DATE May 20, 2026
FOR Telluride Public Works Transit Building Addition
Telluride, Colorado
EIDOS PROJECT NO. 23019

CONTRACTOR QUESTIONS

END OF ADDENDUM NO. 5

Sheet Title:
Reflected Ceiling
Plan

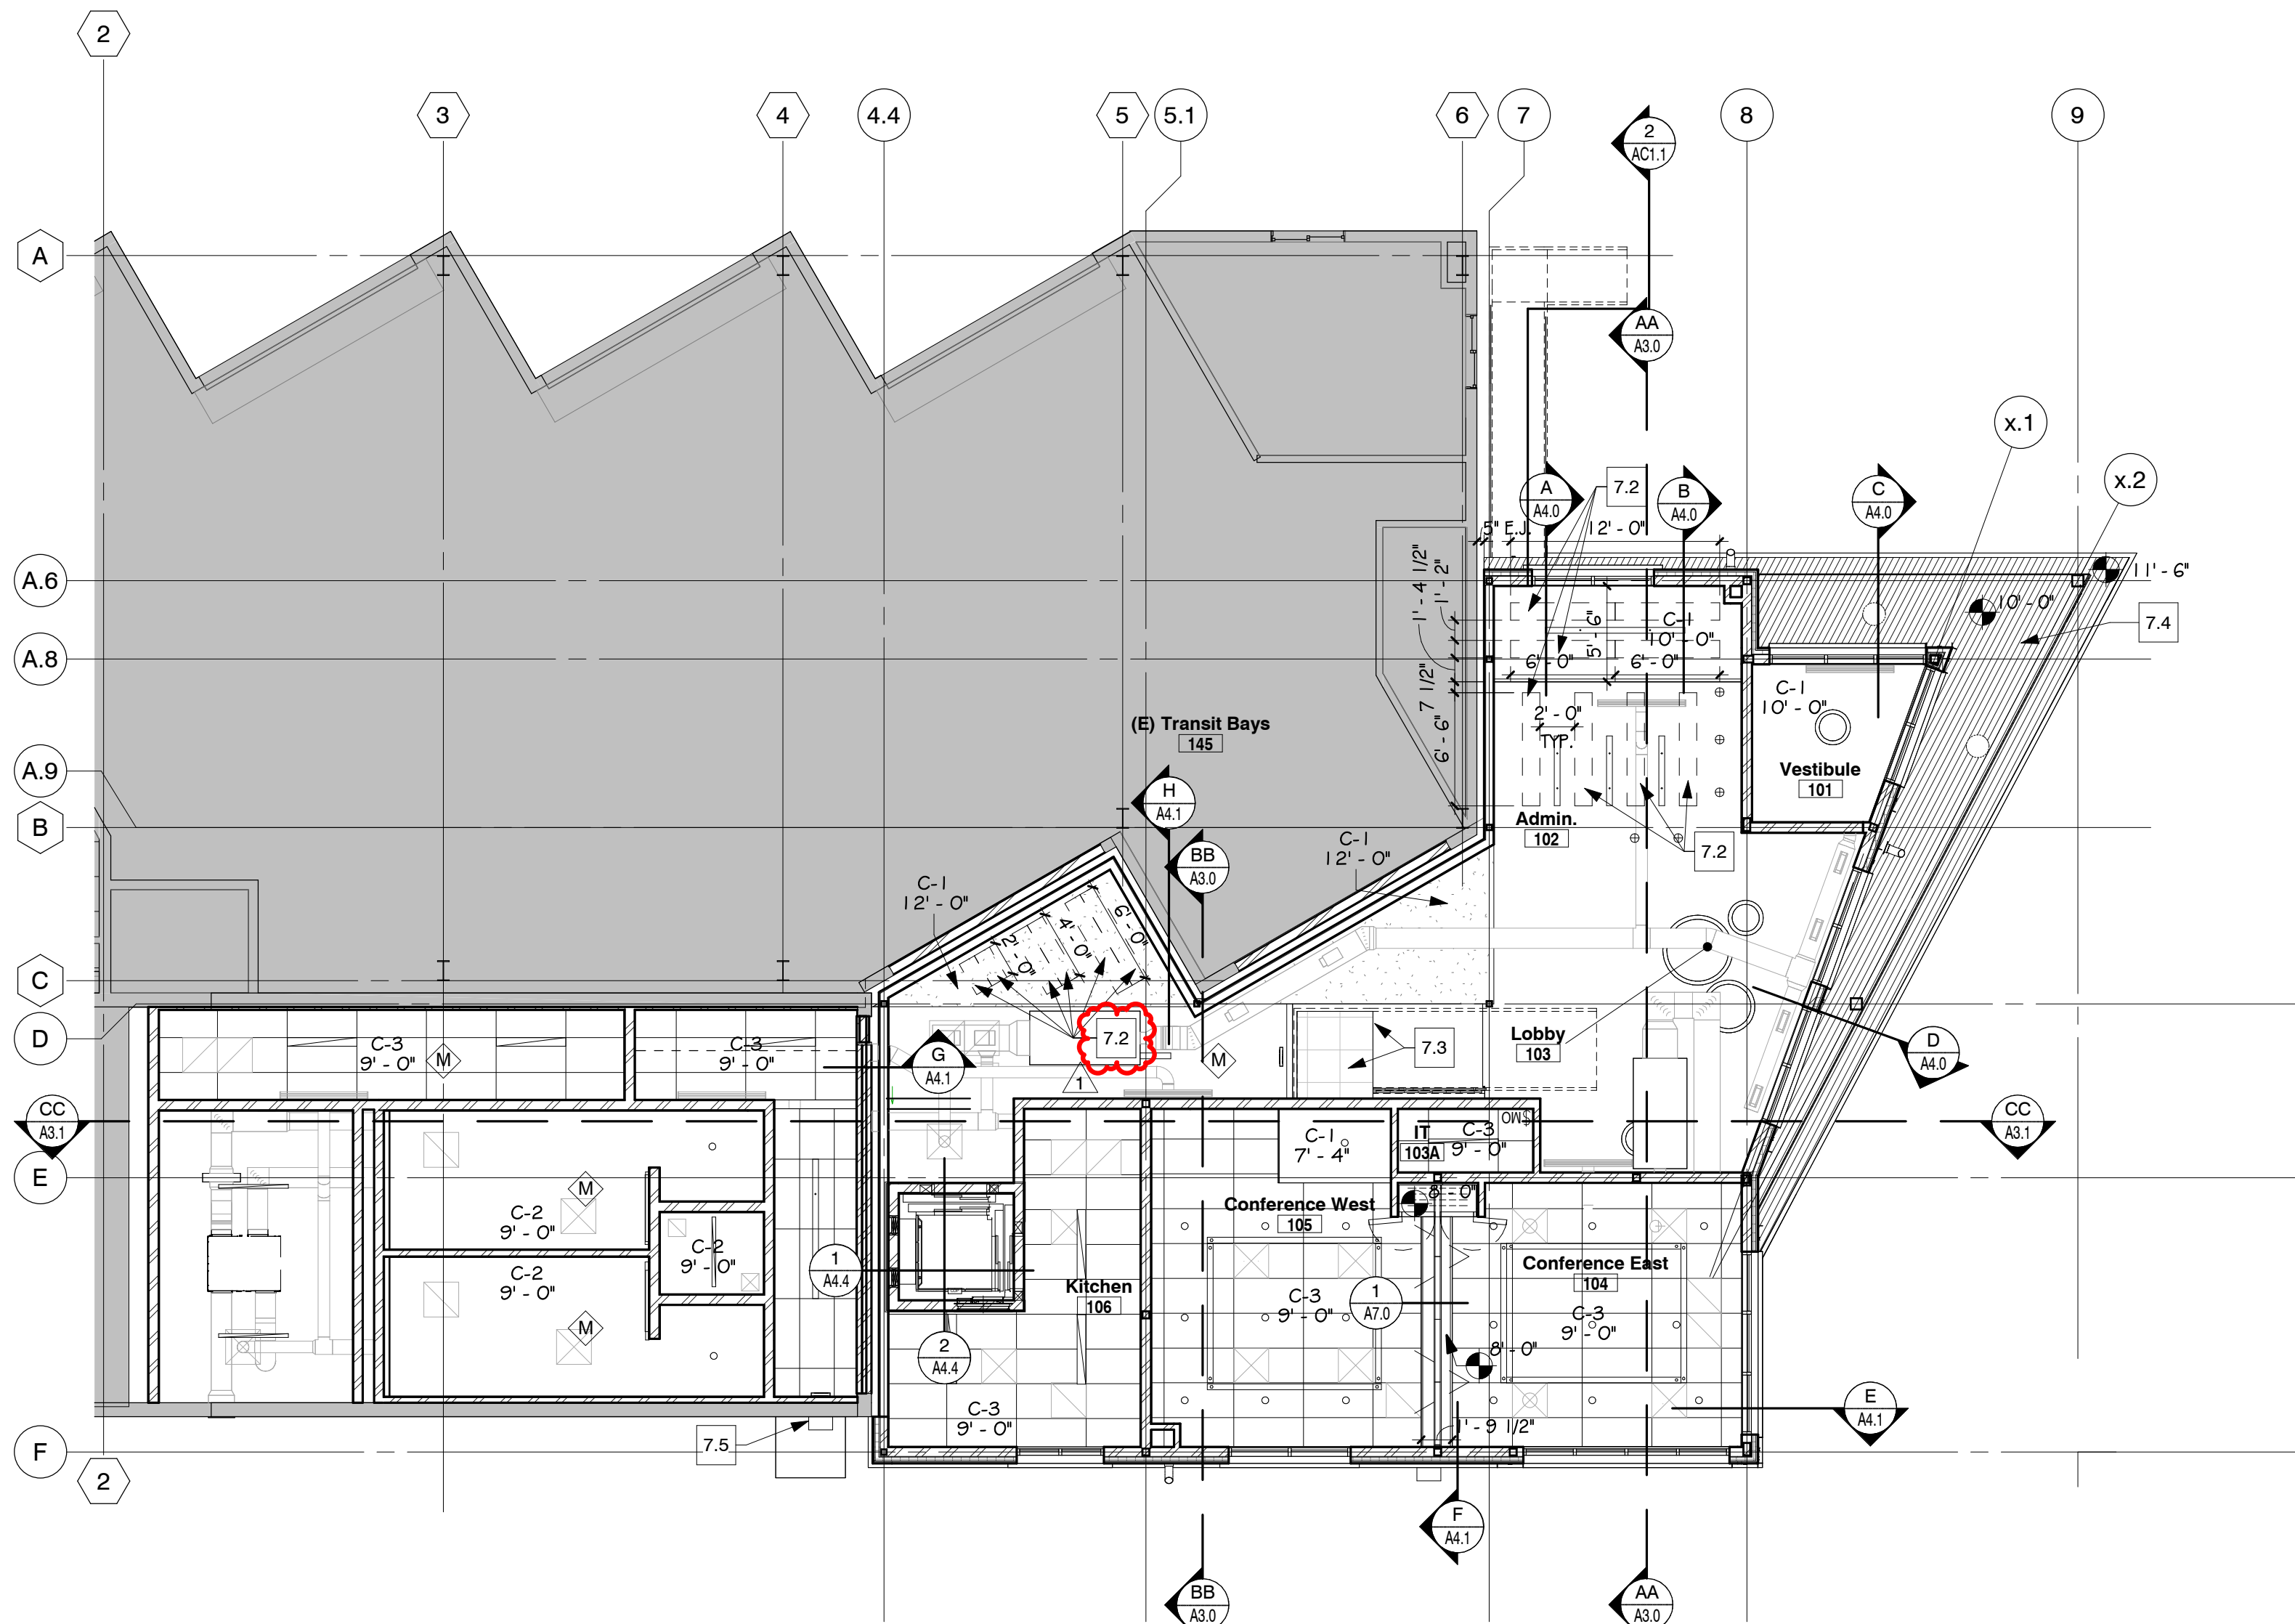
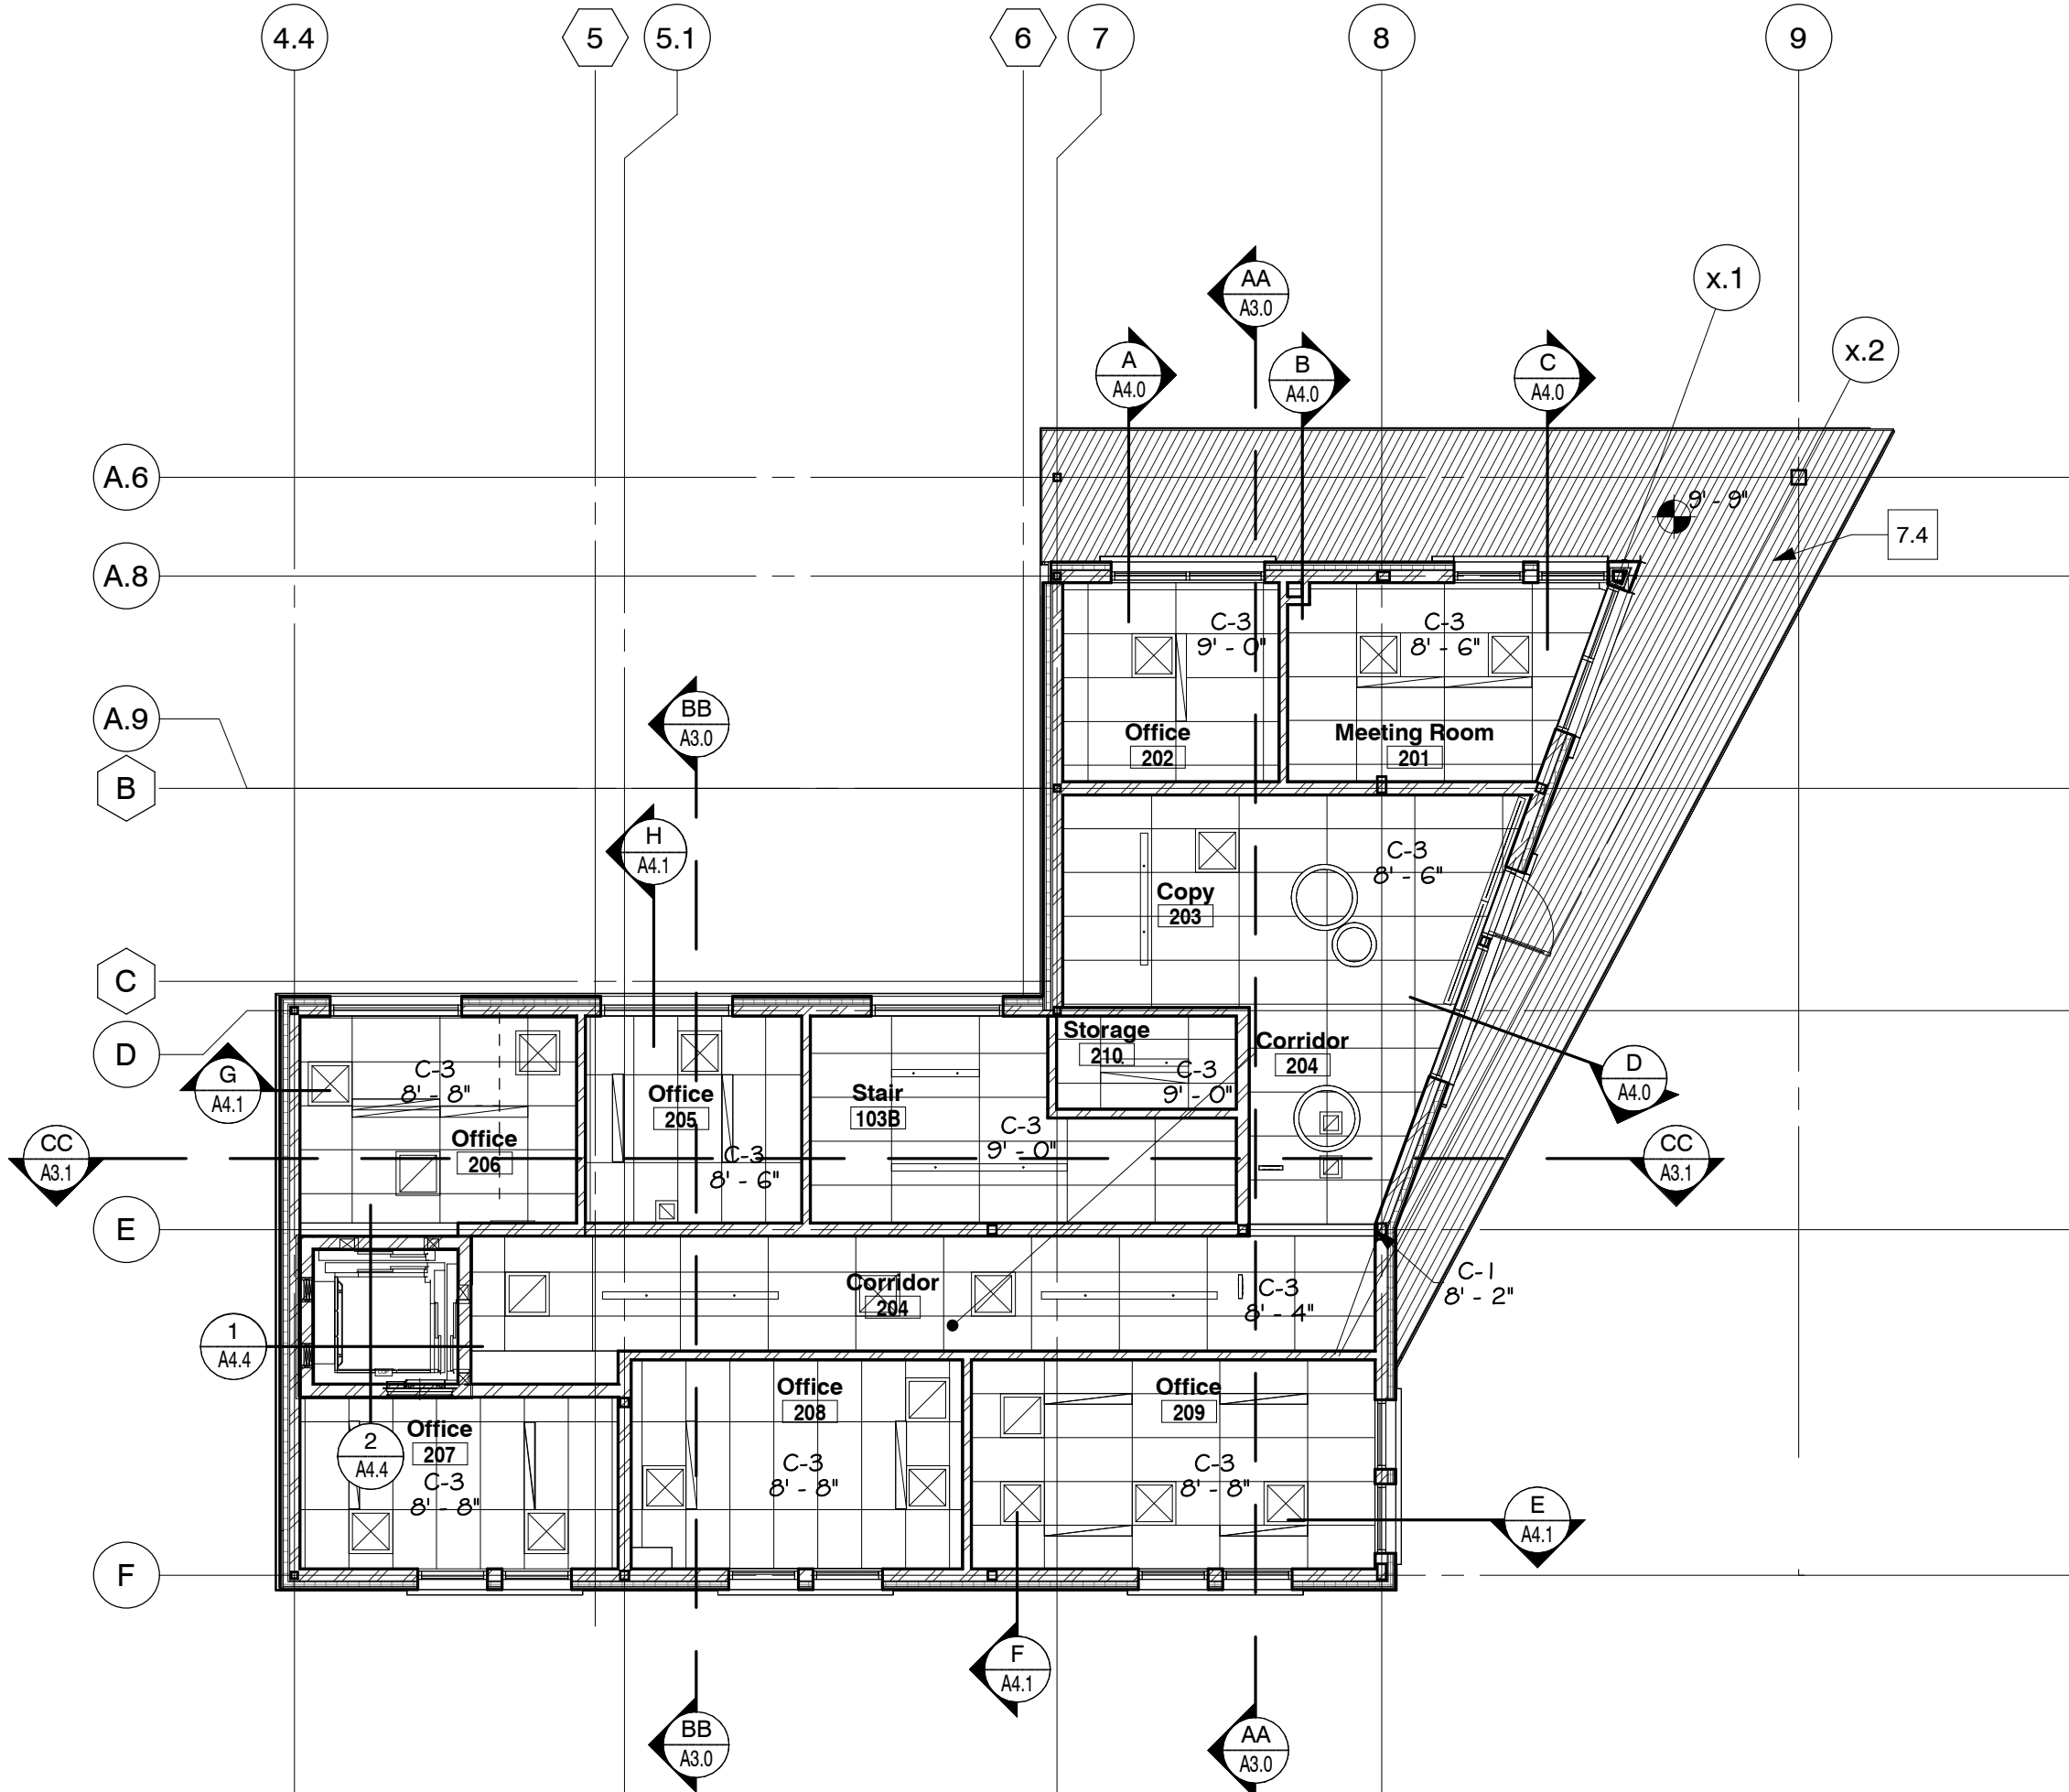
8. The project scope and code review indicate that fire suppression and fire alarm systems are to be provided throughout the combined existing and new building. Can an overall existing building reflected ceiling plan, or a ceiling plan identifying the existing ceiling conditions, be provided to show where and what types of ceilings may need to be removed, modified, patched, or replaced to accommodate the new fire suppression piping in the existing building?

Answer: Attached are the available ceiling plans from the existing administration area. The vehicle bays do not have finished ceilings. Drawings are not verified with actual conditions, but shall be used for bidding purposes.
